Appendix 2 Consultation Responses from internal and external consultees

Stakeholder	Question/Comment	Response
INTERNAL: Carbon Management/ Energy & Sustainability	<p>Carbon Management Response 31/10/2024</p> <p>In preparing this consultation response, we have reviewed:</p> <ul style="list-style-type: none"> • Energy Statement prepared by Ensphere Group Ltd (revision 4 dated June 2024) • Sustainability Statement prepared by Ensphere Group Ltd (revision 7 dated Aug 2024) including BREEAM Pre-Assessment • Thermal Comfort Analysis prepared by Ensphere Group Ltd (revision 1 dated Sept 2024) • Building Life Cycle Assessment prepared by Ensphere Group Ltd (revision 1 dated Jun 2024) • Landscaping and UGF Report prepared by James Smith (dated July 2024) • GLA carbon emissions reporting spreadsheet • BRUKL Be Lean and Be Green worksheets • Existing and Proposed Drawing Sets prepared by Mata Architects (dated June 2024) • Mechanical Plant Report prepared by SVM (revision 1 dated Aug 2024) • Roof plan showing PV layout prepared by Mata Architects (dated Aug 2024) • ASHP and plant room drawing prepared by Mata Architects (dated Aug 2024) • PV Proposal by Zenergy (dated Sept 2024) • PV panel d

Proposed roof plan

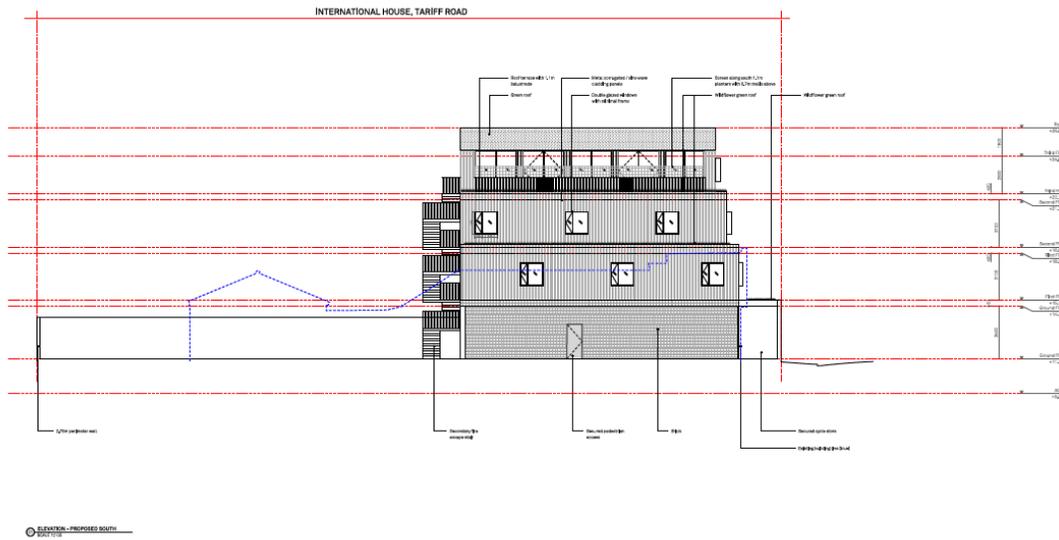
Stakeholder	Question/Comment	Response
	<ul style="list-style-type: none"> - Please indicate the external plant space onto roof plan and elevations; and provide the details of this full height enclosure in terms of visual and noise mitigation. - How much of the heating/hot water demand will be met by the proposed types of heat pumps? If this cannot be met fully, how will this be supplemented? - What is the Seasonal Coefficient of Performance (SCOP), the Seasonal Performance Factor (SFP) and Seasonal Energy Efficiency ratio (SEER) of the ASHP? - Please clarify the proposed use of hot water provided by local electric water heaters, e.g. for use in bathrooms and kitchens? <p>Energy – Be Seen</p> <p>London Plan Policy SI2 requests all developments to ‘be seen’, to monitor, verify and report on energy performance. The GLA requires all major development proposals to report on their modelled and measured operational energy performance. This will improve transparency on energy usage on sites, reduce the performance gap between modelled and measured energy use, and provide the applicant, building managers and occupants clarity on the performance of the building, equipment and renewable energy technologies.</p> <p>The applicant should install metering equipment on site, with sub-metering by the non-residential units. A public display of energy usage and generation should also be provided in the main entrance area to raise awareness of residents/businesses.</p> <p>The applicant will undertake a programme of aftercare support as part of its handover process, which will also align with the BREEAM Ma05 credit requirements. An energy monitoring system with metering will also be installed to allow the collection of data.</p> <ul style="list-style-type: none"> - Please confirm that sub-metering will be implemented for commercial units. - What are the unregulated emissions and proposed demand-side response to reducing energy: smart grids, smart meters, battery storage? - Demonstrate that the planning stage energy performance data has been submitted to the GLA webform for this development: (https://www.london.gov.uk/what-we-do/planning/implementing-london-plan/london-plan-guidance/be-seen-energy-monitoring-guidance/be-seen-planning-stage-webform)
